CNRO-2003-00048

SUBJECT: Entergy Operations, Inc.
Response to Requests for Additional Information Pertaining to
Relaxation Requests to NRC Order EA-03-009 for In-Core
Instrumentation Nozzles

Arkansas Nuclear One, Unit 2
Docket No. 50-368
License No. NPF-6

**RESPONSES TO THE NRC'S
REQUEST FOR ADDITIONAL INFORMATION**

Figure 1a: Axisymmetric Counterbore Nozzle FEA model for Internal pressure

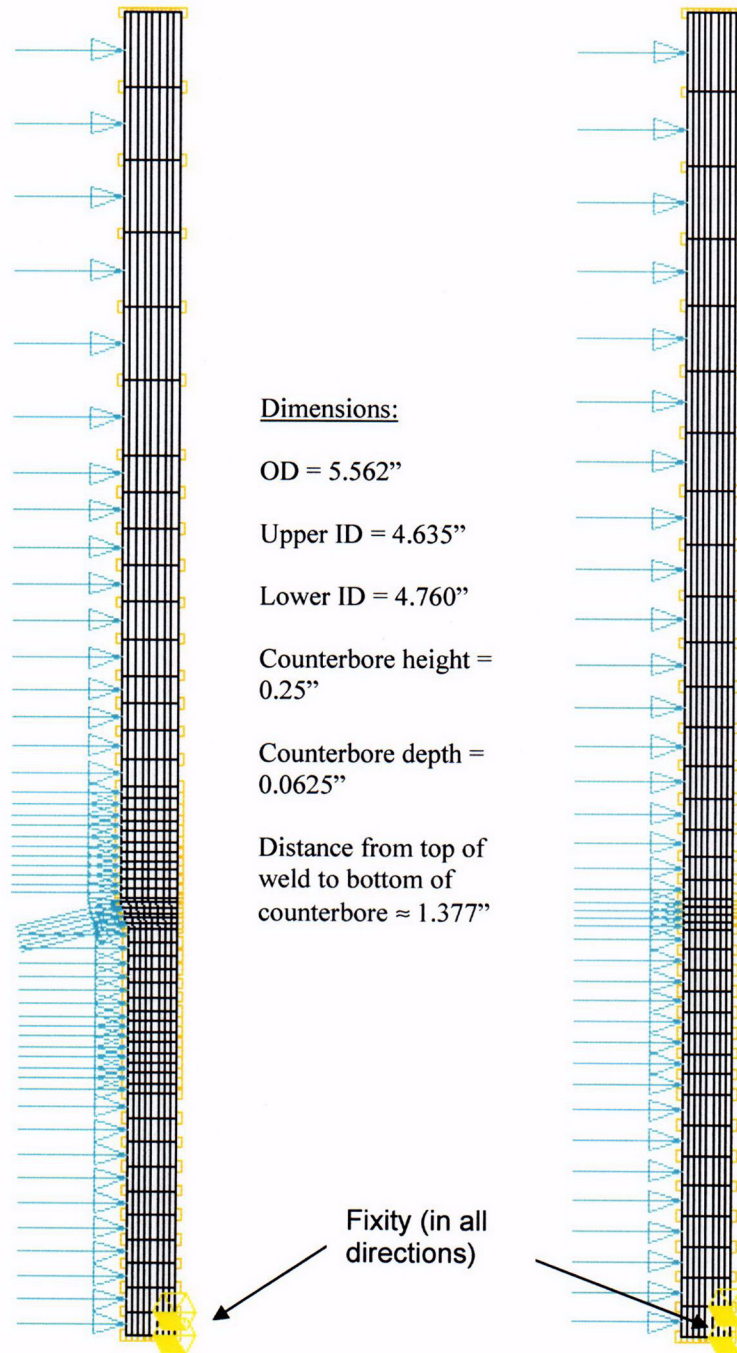
It is stated in Section 3.1 of Enclosure 2 of your September 3, 2003 application [Entergy letter CNRO-2003-00035] that the counterbore was not explicitly modeled. This modeling is acceptable if the propagating crack tip is at some distance from the highly stressed area caused by the counterbore. However, for crack tips located within this highly stressed area such as Case 4 of your fracture mechanics analysis, you may need to evaluate the impact of the stress concentration factor (e.g., from Peterson's handbook) caused by the counterbore on the applied K calculation.

To address the explicit effect of a counterbore on the inside diameter (ID) of a cylinder (such as the ICI nozzle), several simplified finite element analysis (FEA) models were performed to quantify the relative impact of the counterbore on the applied stresses on the ICI nozzle. These stresses are used in the deterministic fracture mechanics evaluation of an axial surface flaw in the counterbore region. Two nozzle configuration models were evaluated:

The flaw in the 0.88-inch blind zone is subject to membrane and bending residual + operating loads. To simulate the applied hoop loading conditions for which the axial flaw would be subject to and propagate in, two models for each nozzle configuration were constructed. The first set of models consisted of a unit (1000 psi) internal pressure load to simulate the contribution of the applied pressure loading in the nozzle and fixity applied on the OD at the bottom of the nozzle to simulate weld or head restraint. Figures 1a and 1b below show the two internal pressure models. The second set of models consisted of a horizontal unit force (1000 lb. or 1 kip) applied to the OD of the nozzle, with the top of the nozzle (away from the region of load application) fixed, to simulate the "hoop bending" effect caused by the J-groove weld residual stresses. This load condition will cause nozzle ovality, which is the primary cause of the hoop membrane and bending stresses in the nozzle. Figures 4a and 4b show the hoop bending load models.

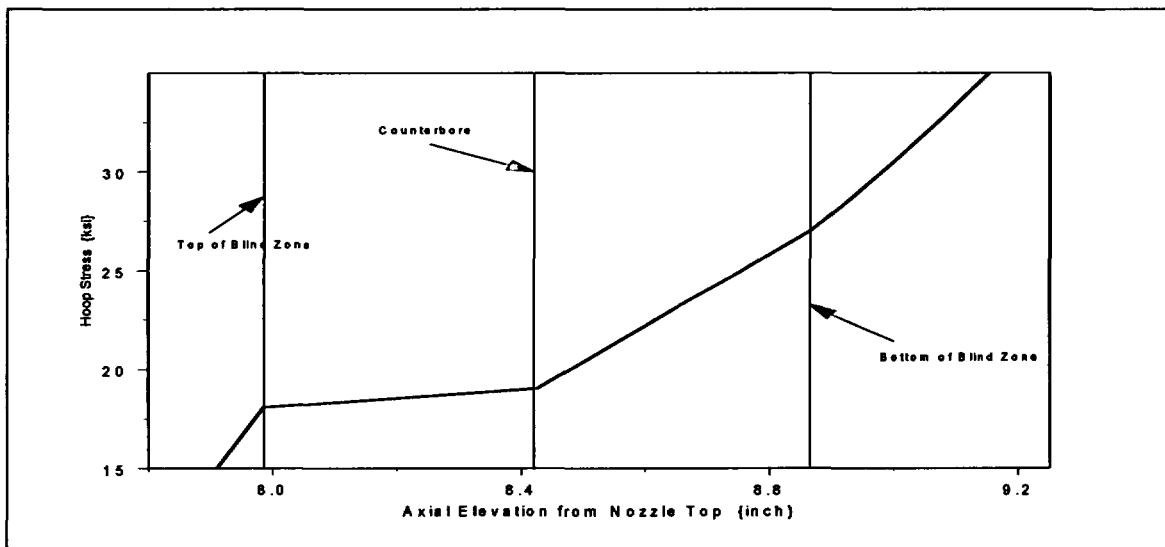
The applied K calculation for inside diameter (ID) surface flaws employed the "moving average scheme," which was also used in the fracture mechanics analyses for ID and outside diameter (OD) surface flaws for control element drive mechanism (CEDM) nozzles. An error analysis of this scheme is not necessary in the CEDM nozzles application because the results for the corresponding through-wall flaws are limiting with only one exception, and this exception is due to your approach of assuming the upper crack front for an initial OD or ID flaw to be 0.16 inch ahead of a corresponding through-wall flaw. In the in-core instrumentation (ICI) application, since the ID surface flaw is the only concern, a quantitative error analysis is required. One way to estimate the error is to find the ratio between the applied K for a crack with a concentrated opening force acting close to the crack tip and that for a crack with your average opening stresses. The concentrated force represents the difference between the stresses in the moving segments and the average stress.

The evaluation to determine the error by using the moving average stress for determining the stress intensity factor (SIF) followed the guidance provided in the NRC's question. The stress distribution considered for this evaluation was the ID surface stress in the counterbore region. The finite element analysis (FEA) nodal hoop stresses for the ID surface were fit with a third order polynomial. The curve representing the stress distribution is shown in Figure 1. In this figure the top and bottom of the blind zone together with the location of the counterbore are provided. The postulated crack encompasses the entire blind zone and is 0.88 inch long.

The stresses used to calculate the force used in the wedge crack model were from the stress distribution shown in Figure 1, whereas the stresses used for the CCP model were the moving average stresses obtained using the formulation described in Engineering Report M-EP-2003-003 (Enclosure 2 of Entergy letter CNRO-2003-00035). It is recognized that since the assumed crack encompasses the entire blind zone, the crack tip at the top of the blind zone is at a considerably lower stress. Hence, the average stress applied to the crack would be lower than the stress prevailing at the crack tip located close to the bottom of the blind zone. The wedge force was applied at the location of the initial crack tip (for the first iteration) and the half crack length was 0.458 inch. The wedge force model would provide the incremental SIF produced by the higher stresses at the crack tip at the bottom of the blind zone. The applied stress used for the CCP model was the average stress described above. Thus, the sum of the SIF from the two models would provide the prevailing SIF at the crack tip closest to the bottom of the blind zone. A ratio of the total SIF divided by the SIF obtained from the CCP model would provide the estimated error in the determination of the SIF using the model used in Engineering Report M-EP-2003-003.
